HUGHES SERVICE INFORMATION NOTICE

NOTICE NO. N-75.2*

INSPECTION - MAIN ROTOR LEAD-LAG AND
FLAPPING HINGE BOLTS, P/N HS1446-10-68

All Model 269A/A-1/A-2 Helicopters
All Model 269B Helicopters

FIGURE 1. INSPECTION - LEAD-LAG AND FLAPPING HINGE BOLTS, P/N HS1446-10-68

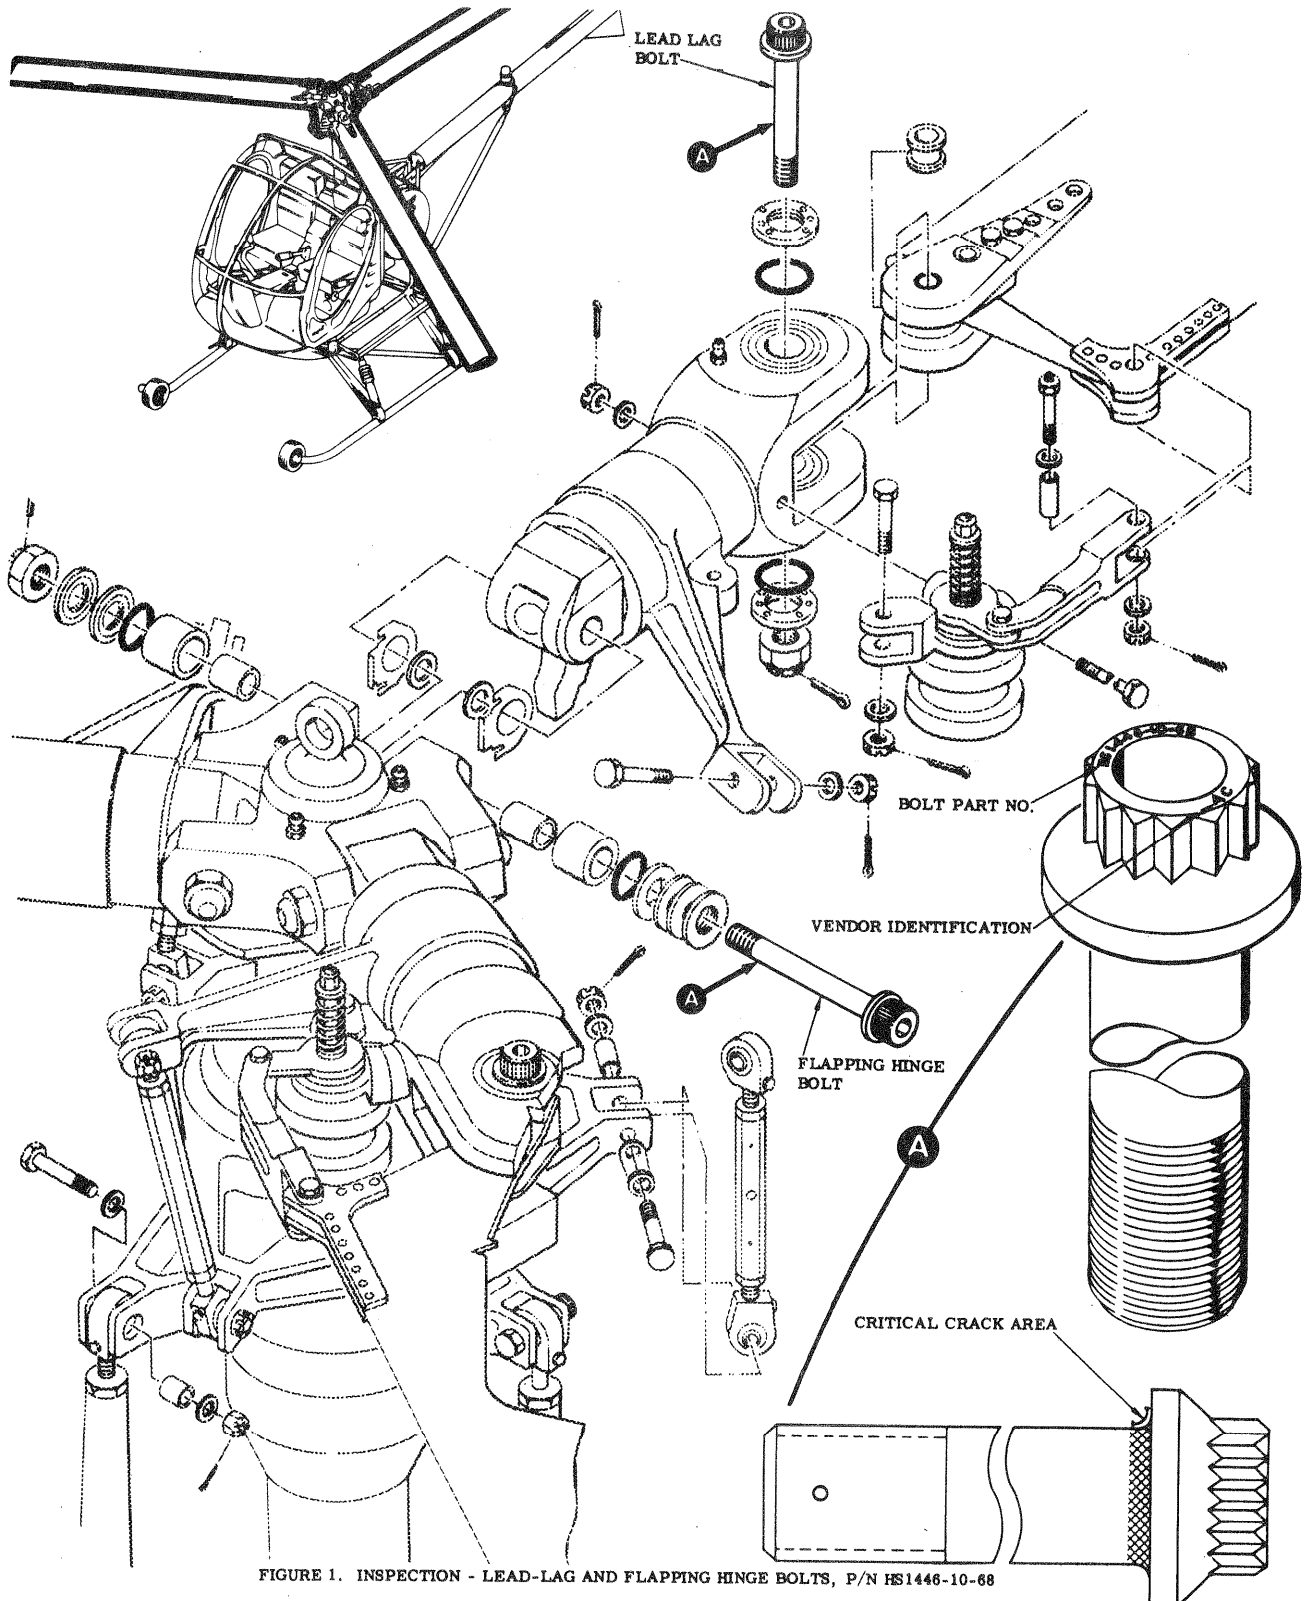
a. Visually inspect all P/N HS1446-10-68 bolts installed on helicopter (two bolts on each main rotor pitch bearing assembly), to determine if a vendor identification (AC) is impression-stamped on top of bolt heads. (See Figure 1)

1. Remove and dye penetrant inspect or magnaflux inspect all (AC) bolts for evidence of cracking. Pay particular attention to area of bolt shank at radius of bolt head. (See Figure 1)
 - (a) If cracking is noted, identify bolt as unserviceable; install serviceable bolt prior to next flight.
 - (b) If no evidence of cracking is found, paint green dot in recessed head of bolt, reinstall bolt.
2. At each and every preflight inspection, visually check all lead-lag and flapping hinge bolts (6 bolts total) in main rotor system to determine that no bolt head has separated from shank.
 - (a) Remove all bolts with head separation; install serviceable bolts prior to next flight.

1. Remove main rotor blades and pitch bearing assemblies, as required. Refer to HMI.
2. Remove all (AC) bolts from service; return bolts to HTC-AD for exchange.
3. Reinstall pitch bearing assemblies and main rotor blades, using new P/N HS1446-10-68 bolts other than (AC) type.
